**ADDENDUM TO RFP DOCUMENTS**

<b>SOLANO</b> COMMUNITY COLLEGE 	ADDENDUM #01
	Project: #16-015 Solano Community College District Site Lighting Improvements Project
	Date: March 29, 2016

**ITEM NO. 1 – PLAN SHEET 0.00 – COVER SHEET, INDEX**

**COVER SHEET**  
INDEX

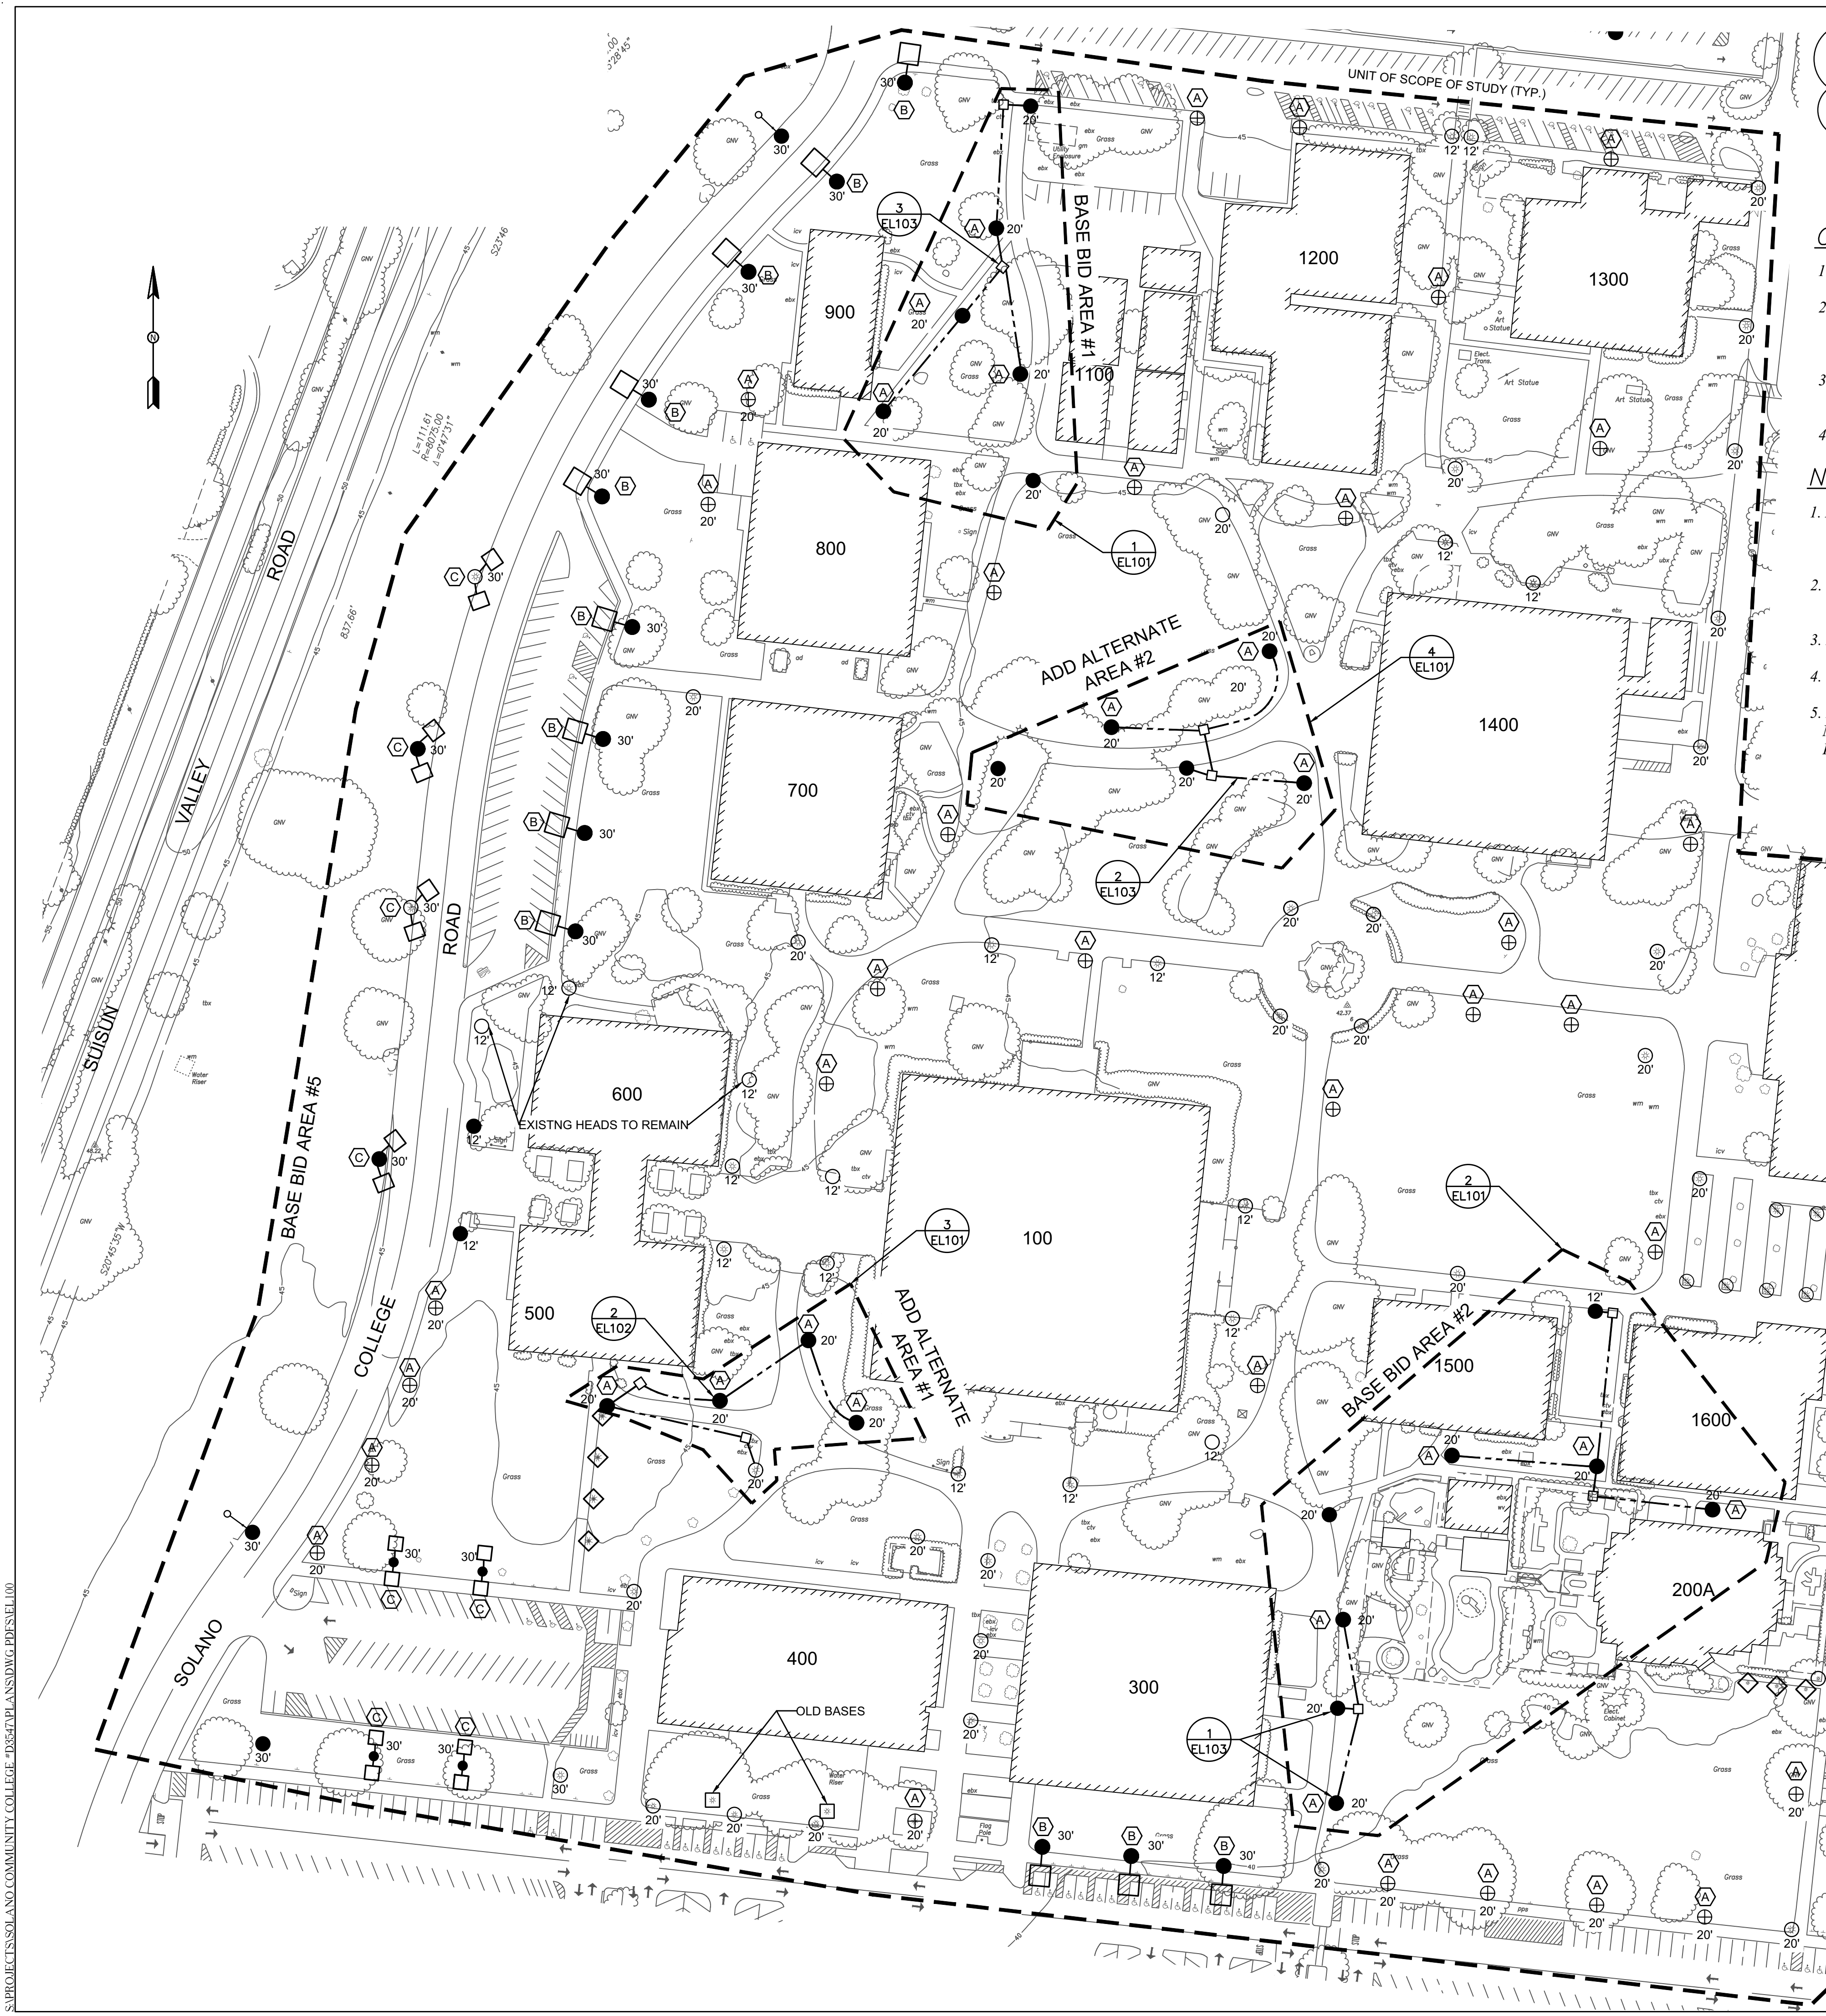
Replace ‘Plan Sheet 0.00’ with attached revised ‘Issue for Addendum #1 – Plan Sheet 0.00’. Revisions include the following:

- Revise ‘Index’ to include additional plan sheets ‘EL 104 – PV POLE LIGHT LOCATIONS (ALTERNATE #3)’.
- Revise ‘Index’ to include additional plan sheets ‘EL 105 – NEW PV POLE LIGHT DETAILS (ALTERNATE #3)’.
- Revise note to clarify scope of work to be ‘BID AREAS #1 & #2 & ADD ALTERNATE AREAS #1, #2 & #3’

NUMBER	REVISION	DATE
	ISSUE FOR BID	03/17/16
	ISSUE FOR ADDENDA #1	03/30/16
ISSUED FOR:		
DATE: 02/15/16		
SCALE: 1"=60'		
DRAWN: FL		
SHEET		
<b>EL100</b>

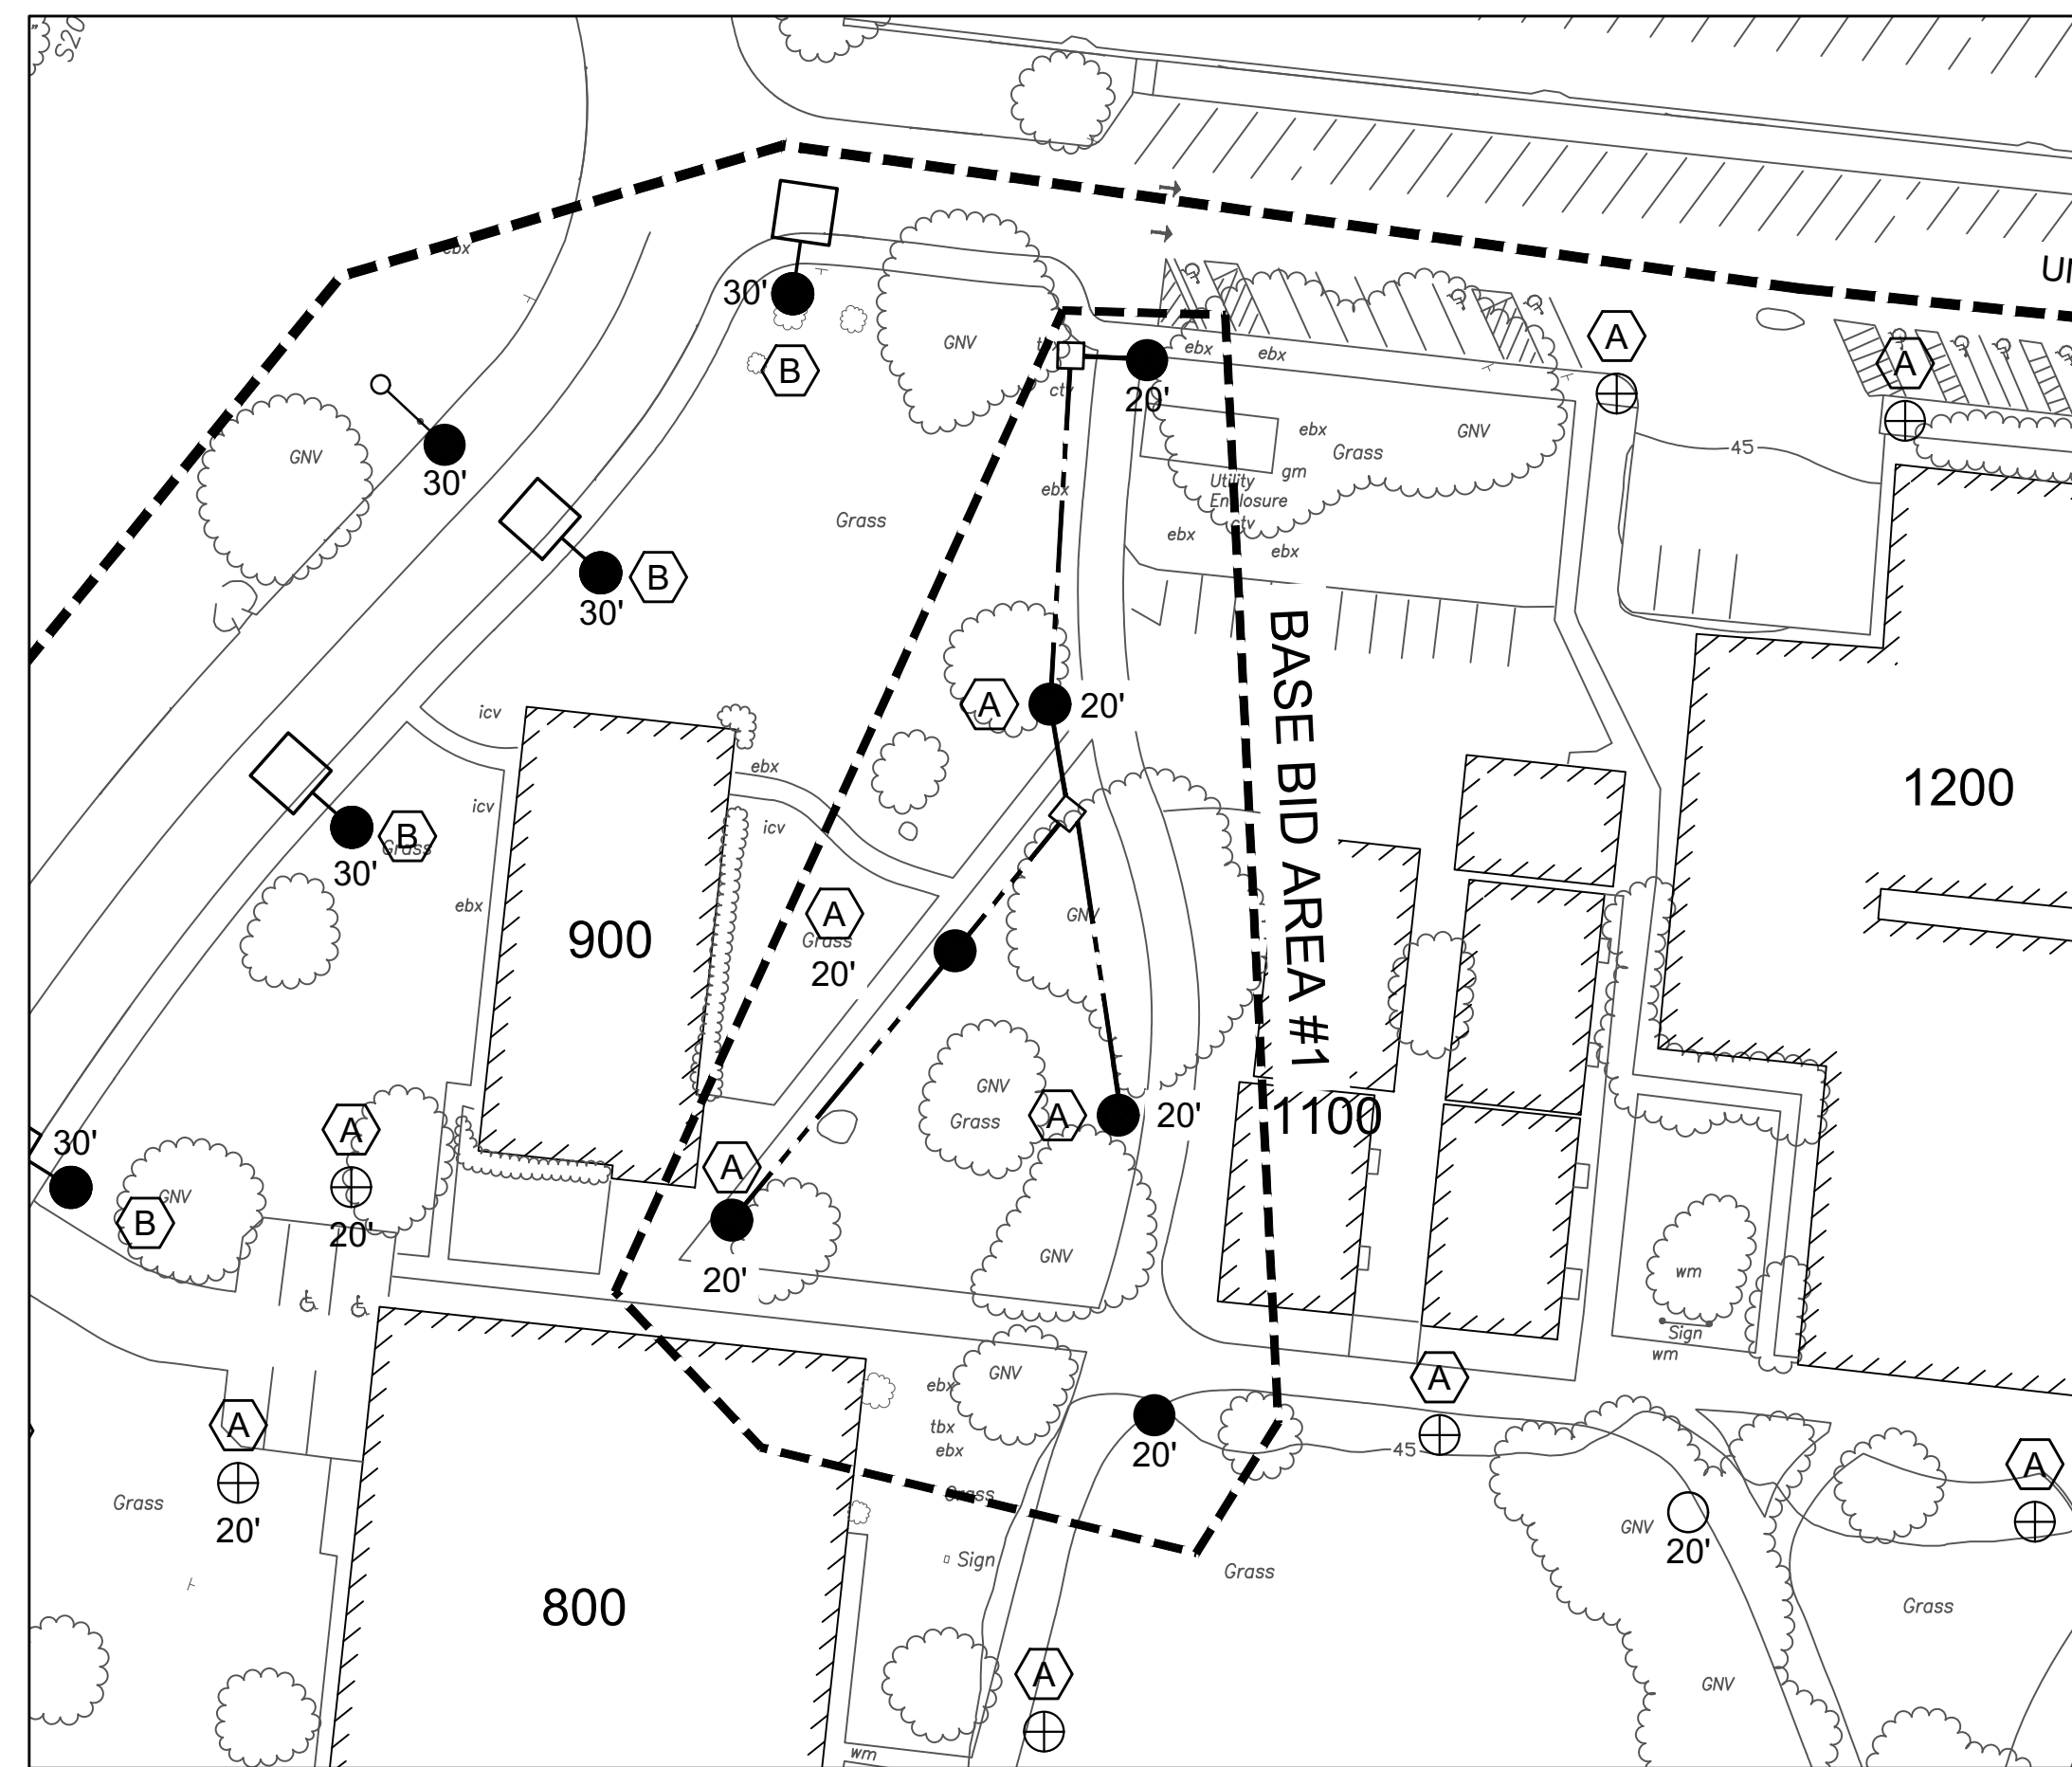
**ITEM NO. 2 – PLAN SHEET EL 100 – SITE LIGHTING IMPROVEMENTS**

Replace ‘Plan Sheet EL 100’ with attached revised ‘Issue for Addendum #1 3/30/16 – Plan Sheet EL 100’. Revisions include the following:

- Delete Fixture Types ‘B’ and ‘C’ from ‘Light Fixture Schedule’.
